# SERVICE BULLETIN

SB1261A

<b>ADDRESSEES</b>	: Owners and users of vehicles mentioned under "Application"
<b>VEHICLE TYPE</b>	: T2100, C2045, CX, TX, TD925US, TDX25US, A300K, A300L, A330, AG300
<b>CONFIGURATION GROUP</b>	: 7.06 Steering – front-axle steering
<b>BULLETIN TYPE</b>	: Service Information
<b>DATE</b>	: June 16 <sup>th</sup> , 2015
<b>SUBJECT</b>	: Bevel gear of front axle steering system
<b>TERMS &amp; CONDITIONS</b>	: Refer to the warranty section further in this Bulletin.

### 3. Procedure to check bevel gear rotating torque

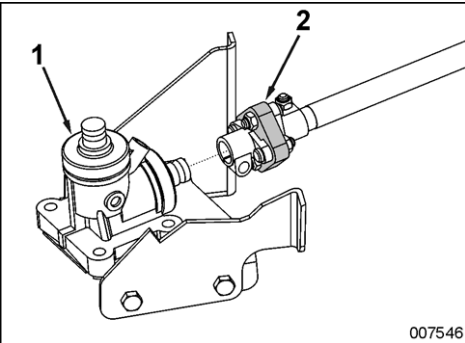
Step	Action
1	Position the bevel gear on a work bench.
2	Position a torque tester suitable for measuring small torques at the input or output shaft of the bevel gear. Check the bevel gear rotating torque by progressively increasing the force on the arm of the tester. The bevel gear must be replaced when the reading on the torque meter exceeds 0,7 Nm (0.52 ft.lbf).

### 4. Procedure to install the new bevel gear

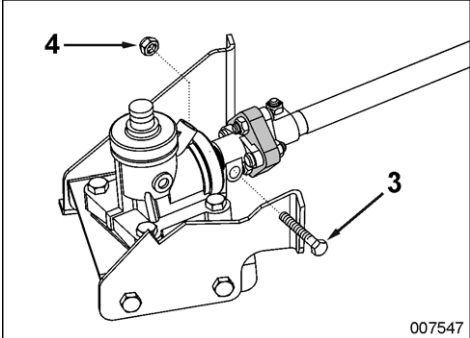
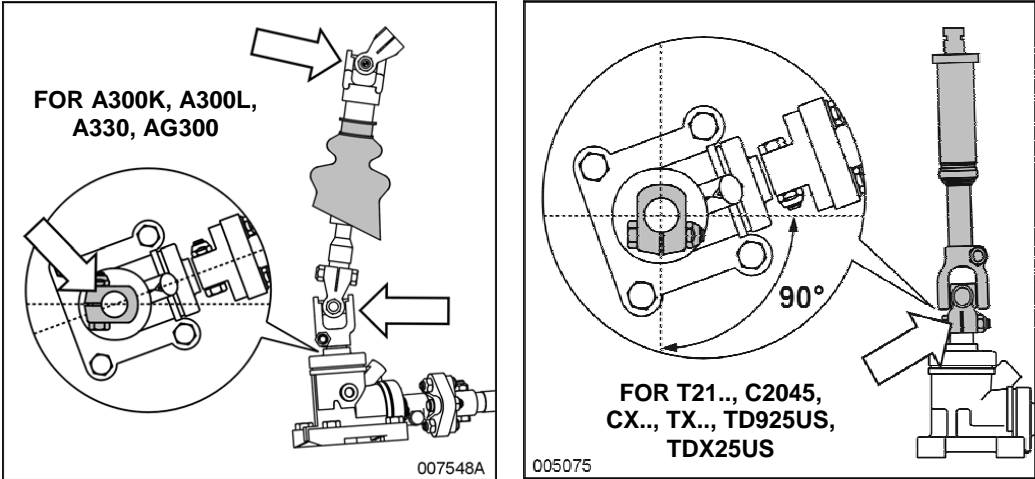
Step	Action
1	Make sure that the front wheels are still in the straight-ahead position.
2	Rotate the bevel gear input shaft to align the marks on the dust cap and on the input shaft itself with the ridge on the housing. This is the “zero backlash” position of the bevel gear.
3	Slide output shaft of bevel gear (1) into elastic coupling (2) of the intermediate shaft. Make sure that the bevel gear remains in the “zero backlash” position during this step (refer to step 2).

4	Secure the bevel gear to the chassis by using four M12 bolts with new self-locking nuts. If there are any shims found under the bevel gear on your vehicle, re-install them. Tighten the nuts to a torque of $70\pm 10$ Nm ( $52\pm 7$ ft.lbf).
5	<p>Install clamping bolt (3) with a new self-locking nut (4). If necessary, slacken the nut of the elastic coupling clamping bolt at the intermediate shaft side to ease installation of bolt (3).</p> 
6	Tighten the clamping bolt(s) of the elastic coupling to a torque of $48+5$ Nm ( $35+3$ ft. lbf).
7	<p>Secure the universal joint of the steering column to the bevel gear with a bolt provided with a new self-locking nut.</p> <ul style="list-style-type: none"> <li>• For busses: ensure that the clamping slot of the universal joint is parallel to the longitudinal vehicle axis (as shown in the left figure).</li> <li>• For coaches: ensure that the clamping slot of the universal joint is perpendicular to the longitudinal vehicle axis (as shown in the right figure).</li> </ul> <p>Tighten the clamping bolt nut of the universal joint to a torque of <math>48+5</math>Nm (<math>35+3</math>ft.lbf).</p>
